CITIZENS COMMENTS

3140 Flagler Ave.
 Key West, Florida
harc@cityofkeywest-fl.gov
Re: Application of “Tropical Soup” for Mallory Square restaurant approval on the site of the Historic Cable Huts

CONCEPT NARRATIVE, Plan dated 5/12/17:

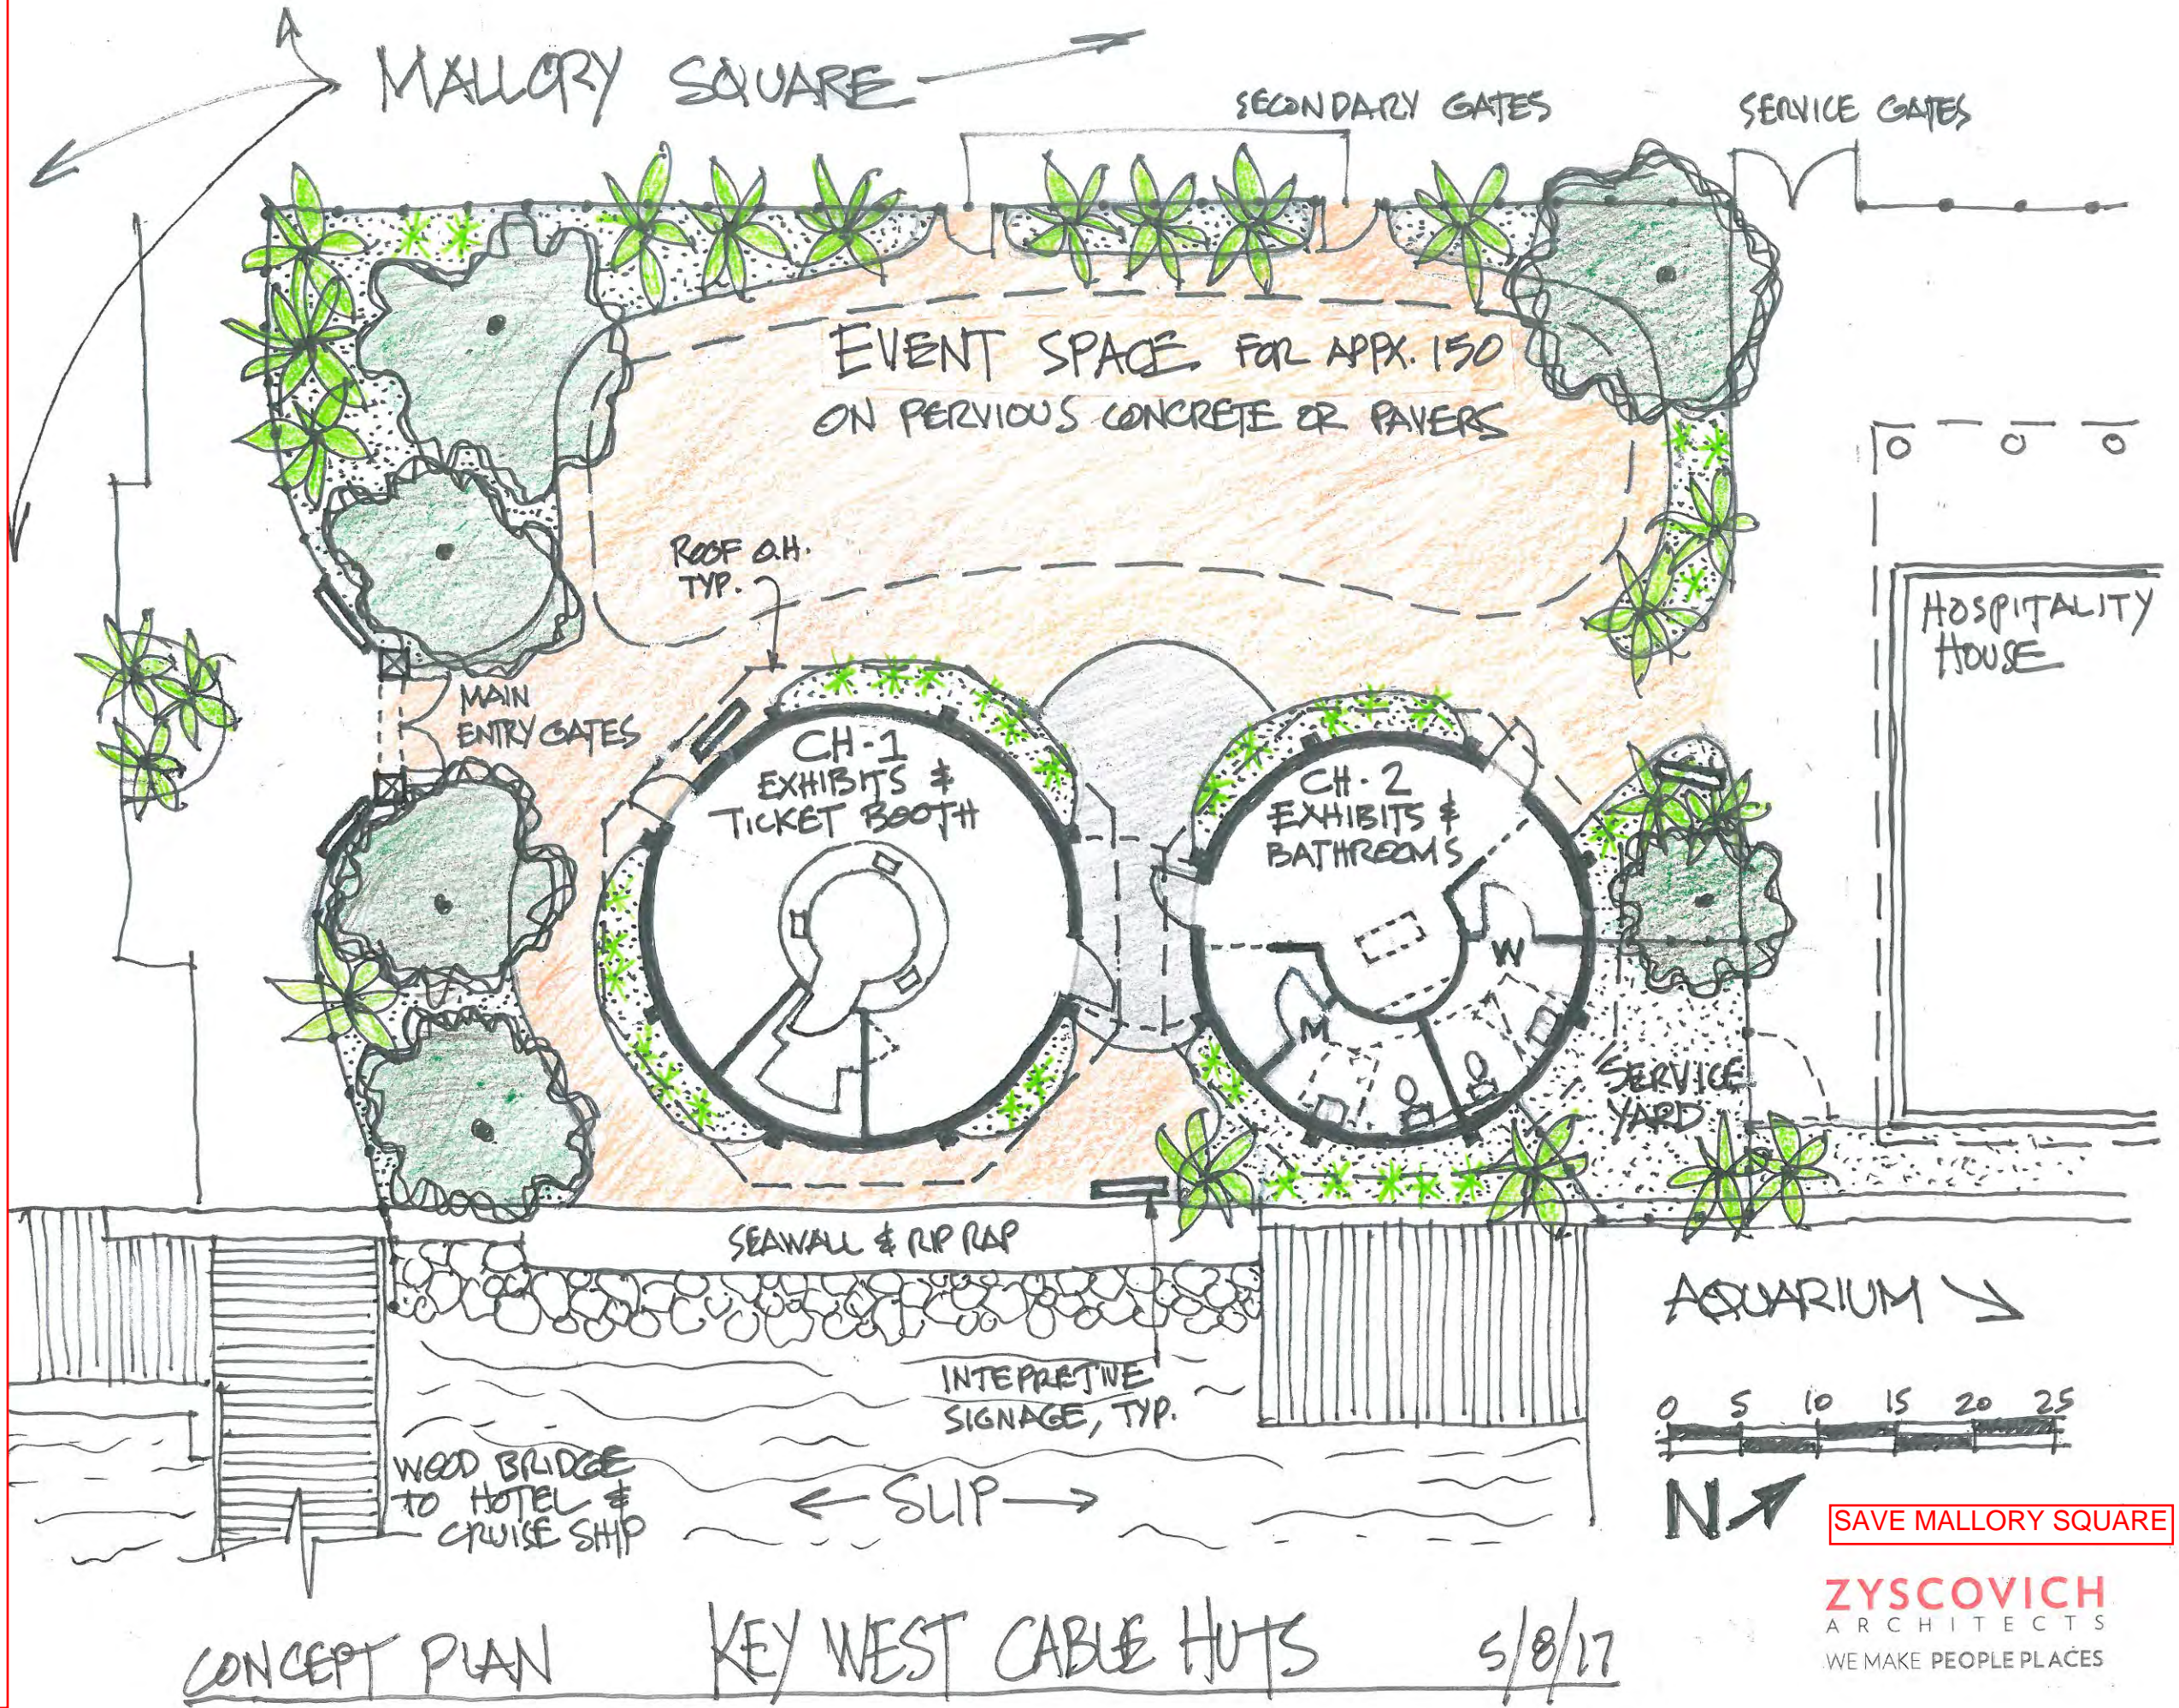
The recent revision to the plan for incorporating one of the Huts into a restaurant, while revealing more of the affected Hut, does not present and interpret this valuable historic resource with integrity. We again strongly urge the Commission to deny this application in favor of a City initiative (in partnership with community and appropriate business interests) to appropriately restore of the Huts as part of cultural activities open to the public, and to their period of maximum historic significance, the early 1930’s. An example plan and narrative is attached here. This is an economically-sustainable approach that does not submit to short-sighted expediency. A plan like this would benefit Mallory Square and surroundings for future generations.

This concept depicts the 2 historic cable huts as restored to maintain their historic integrity. We recommend that the City consider issuing an RFP for restoration and reuse following the Secretary of the Interior’s Guidelines and Standards. The recommended reuse is a combination of a low intensity commercial and cultural venue, combined with historic interpretive exhibits. The site is recommended to be fenced and gated, with native landscape and a generous open plaza suitable for relatively low-volume or non-amplified events and activities.

Redevelopment should accommodate appropriate commercial use that will not generate adverse impacts such as significant waste and noise generation. Use of the site as a bar/restaurant or for amplified music should be precluded because such uses would diverge from and overwhelm the character and scale of the historic resources and surrounding public space. Economic sustainability would be achieved through the incorporation of a sales booth for museum, tour and boating tickets, appropriately-aligned corporate sponsorships, fees for special events in the plaza, and cultural grants.

A restoration plan should include a program like the one shown here, which features exhibits in both huts, a formal ticket booth in CH-1 and a possible kiosk/ vendor table in the inset in CH-2. The buildings would not need to be air conditioned if well ventilated through the louvered roof overhangs augmented with fans, with an option to air-condition CH-1 only. A skylight at the center of each hut would reveal the winch systems used to load the cable into the hut and would also provide additional illumination.
